**Re: EB-2021-0110 – Hydro One Networks**

**HYDRO ONE NETWORKS Inc.**

**Joint Custom IR Distribution and Transmission Application (2023-2027)**

**POWER WORKERS' UNION INTERROGATORIES**

**Ref 3: Exhibit B-2-1 Section 2.8 Page 14 of 28**

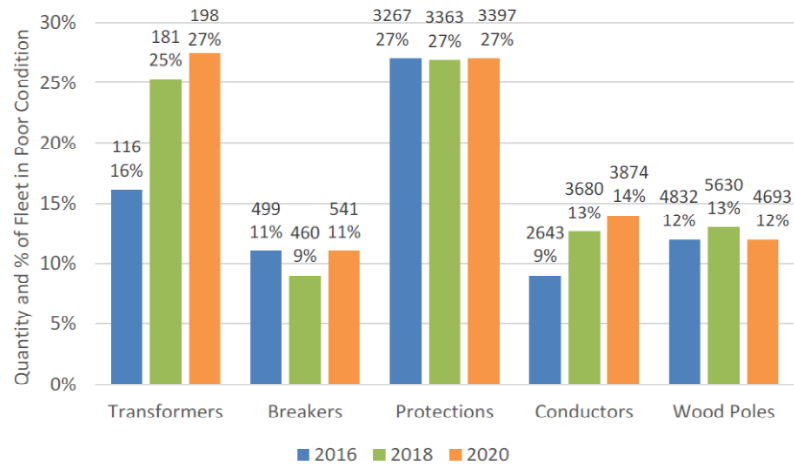
- a) Ref 1 indicates that Hydro One plans to replace 2.7% of the wood pole fleet per year whereas Ref 2 states Hydro One plans to replace 2.9% of its poles per year over the next five years. Please explain the discrepancy.
- b) For each asset category listed in Ref 1, provide a chart that shows the number and share (%) in total asset that are in poor condition, inadequate performance and obsolete. For guidance, please use a chart similar to the following:

Figure 9 – Average Age of Distribution Wood Poles

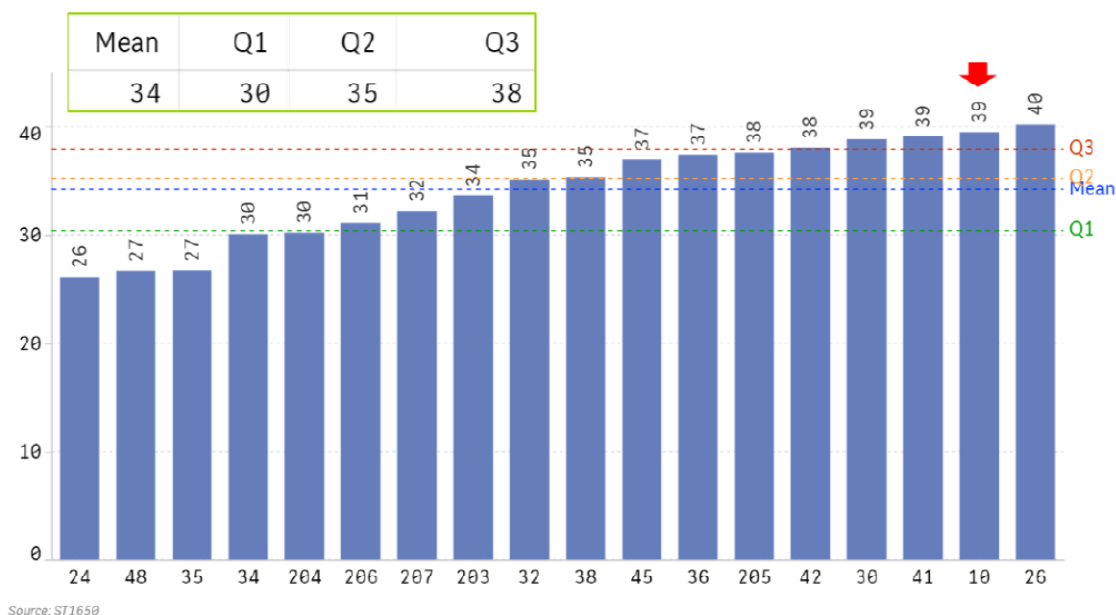
- f) How many of Hydro One's wood poles are both: (i) above the ESL of 47 years; and (ii) categorized as being in better than “poor” condition?
- g) Given that the average age of HONI's poles is the second highest within the comparison panel at 39 years (Ref (3)), compared to the group average of 34 years, does Hydro One believe its proposed rate of replacement would be enough to address the concern cited in Ref (4) in regard to the gap between the ESL for poles and the current replacement rates by the industry?
